Department of Highways Ontario

W.P. 102-65, Bridge Site 20-157
Big Otter Creek Bridge
0.5 Miles West of Highway 10
Highway #3, (Tillsenburgh Diversion)
District #2, London
B.W. 1516

Big Otter Creek Bridge
(Westbound Lane)
0.5 Miles West of Hwy. 19
W.P. 302-65-00, Site 20-157
Highway 3, District No. 2

FOUNDATION INVESTIGATION REPORT
For
Proposed Tillsonburg By-Pass at
Otter Creek Crossing, Hwy. #3
Twp. of Middleton, Co. of Norfolk
District No. 2 (London)
W.J. 66-F-67 -- W.P. 299-65

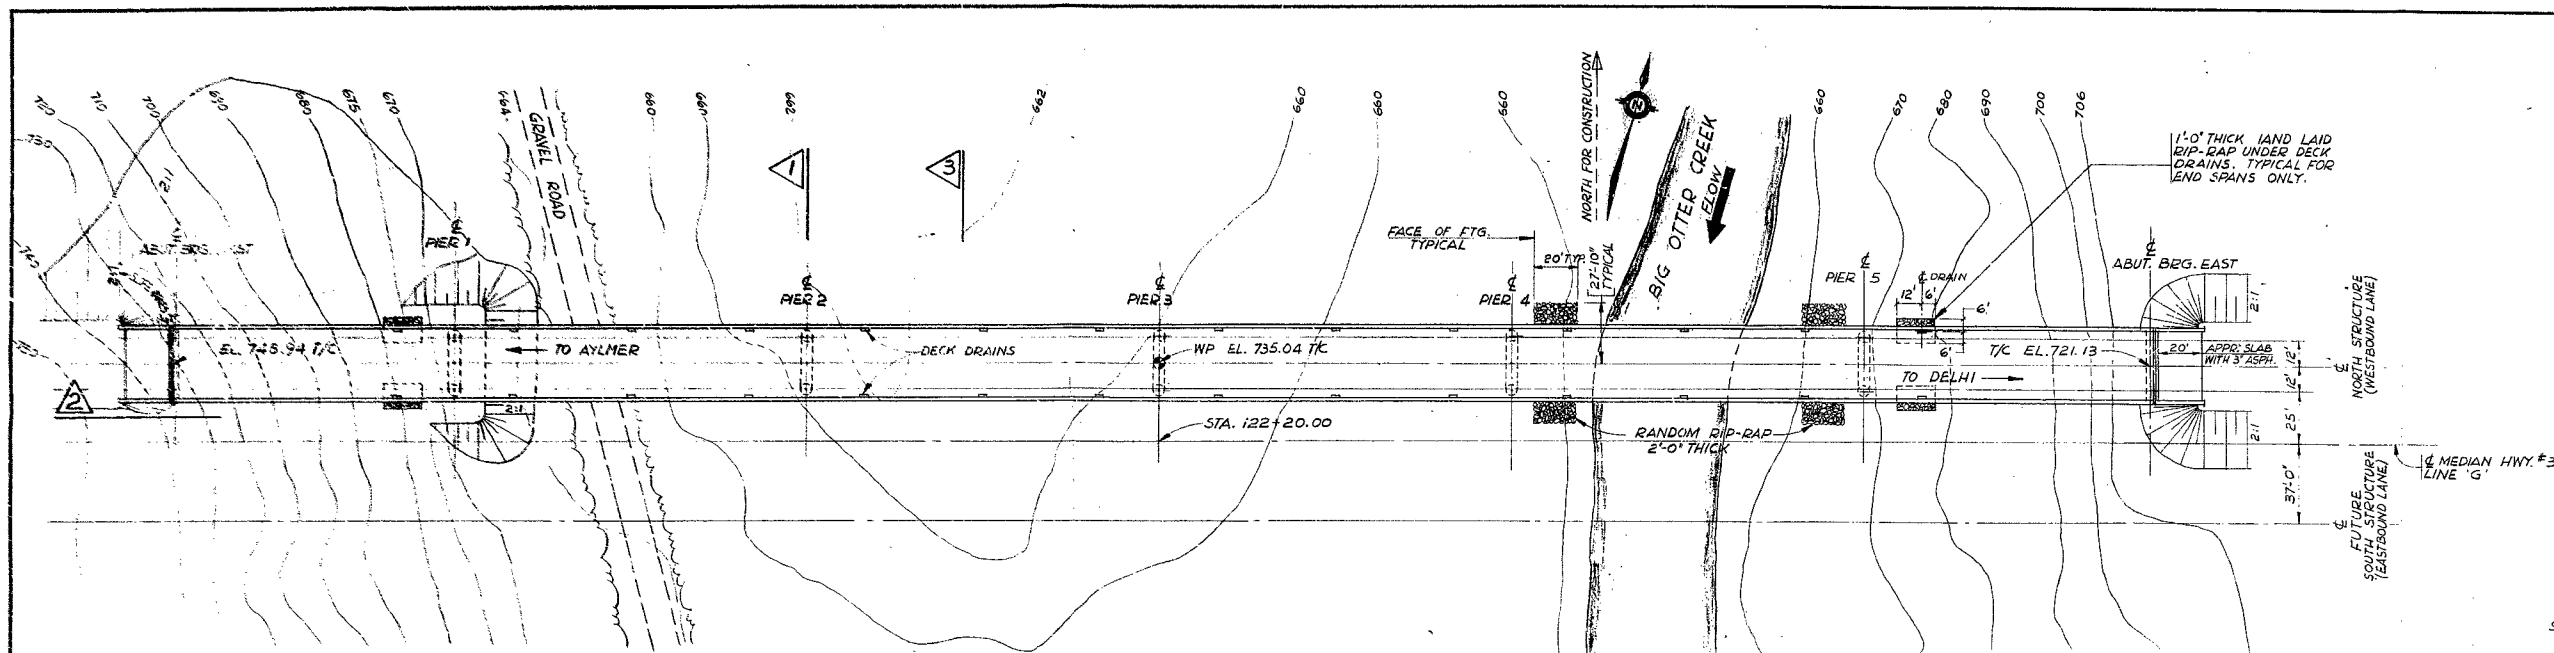
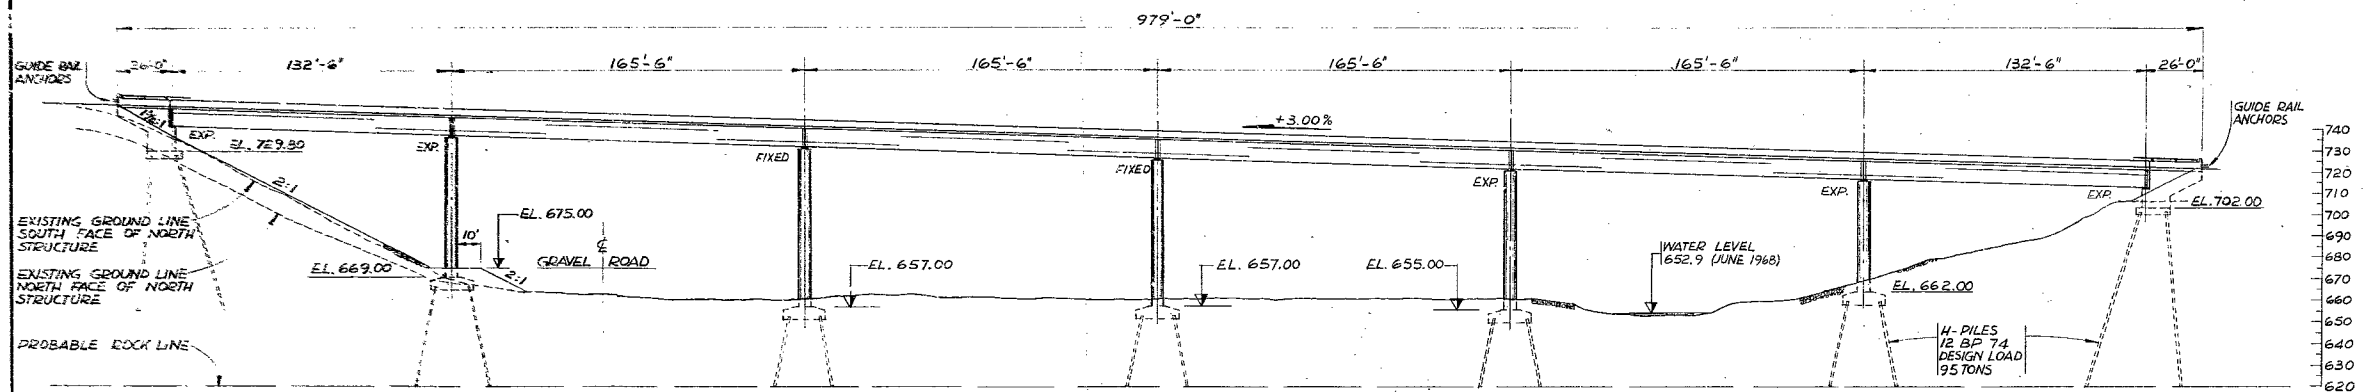
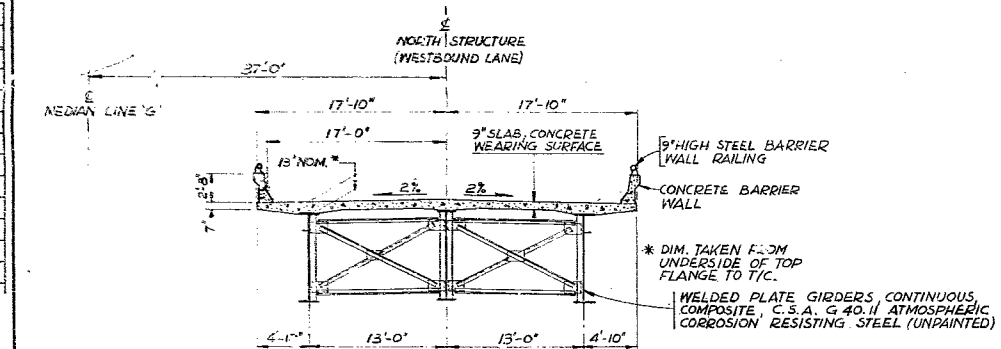
West abutment piles should reach
desired design capacity at el. 665 ±
Otherwise no comments

However, in case it was not apparent to you when you reviewed our drawing, I wish to draw your attention to the west abutment embankment where fill will be placed on the west embankment slope to form a finished surface having a slope of 2:1. Presumably the entire slope will be seeded or sodded so that in time the surface will be protected by vegetation.

- (1) No problems of slope stability provided granular fill is added according to appropriate standards (i.e. benching)
- (2) Problems of erosion due to surface water should be solved by construction of ditches etc.
